ACCESSIBILITY ASSESSMENT REPORT

PROJECT:	300 Burns Bay Road Lane Cove NSW 2066
STAGE:	Development Application Phase
REFERENCE:	25099.3-Access
DATE:	18 February 2026
CLIENT:	Lane Cove Developments No.1 Pty Ltd

Figure 4.1 – Access to park at rear of building

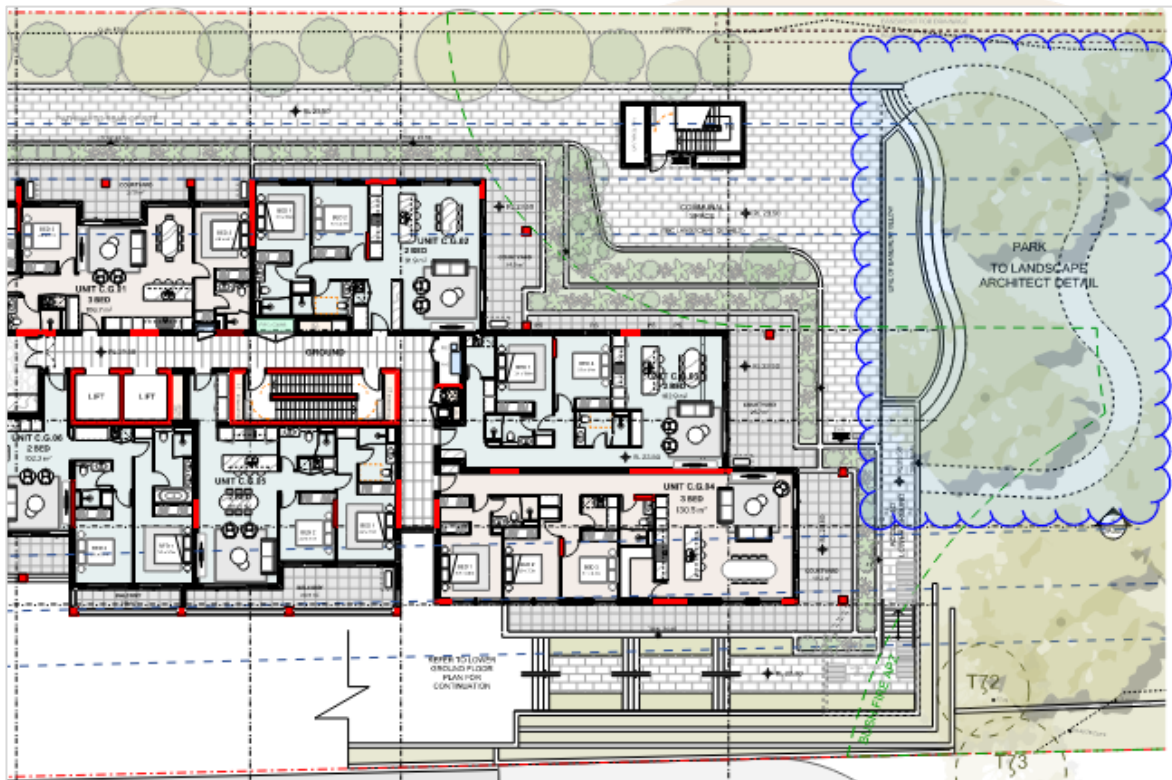
The proposed access to the park at the rear of the building has not been clearly indicated on plan, to demonstrate that the accessway is capable of complying with the requirements of AS1428.1-2021.

Figure 4.2 – Access to building

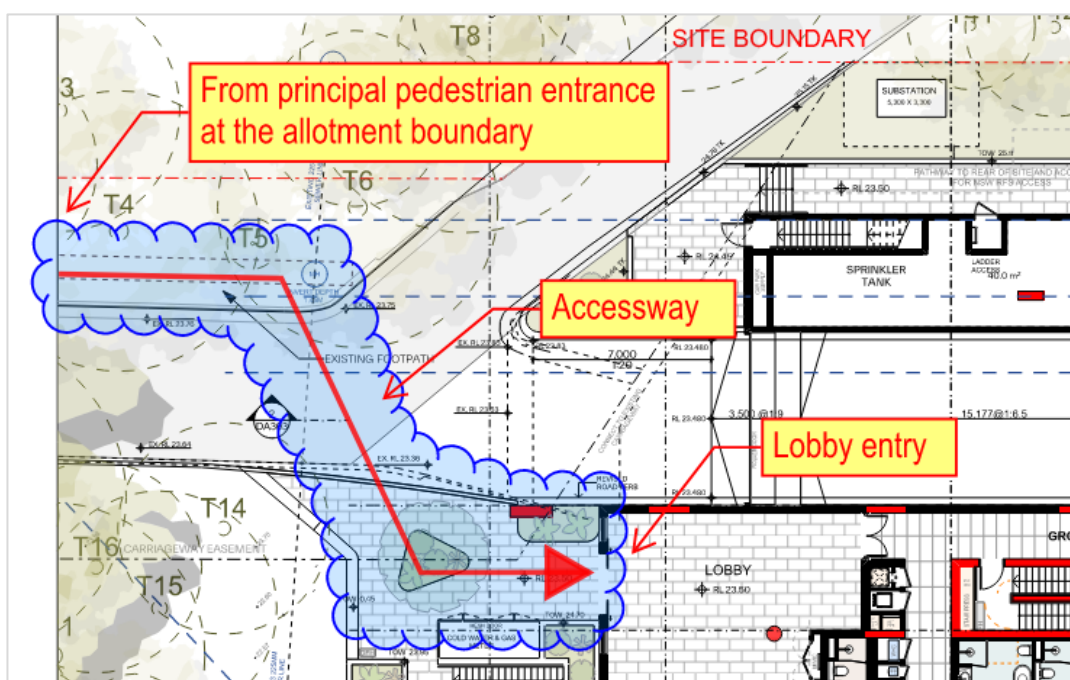
The proposed access to the building from the principal pedestrian entrance at the allotment boundary to the entry lobby on the ground floor has not been clearly indicated on plan, to demonstrate that the accessway is capable of complying with the requirements of AS1428.1-2021.
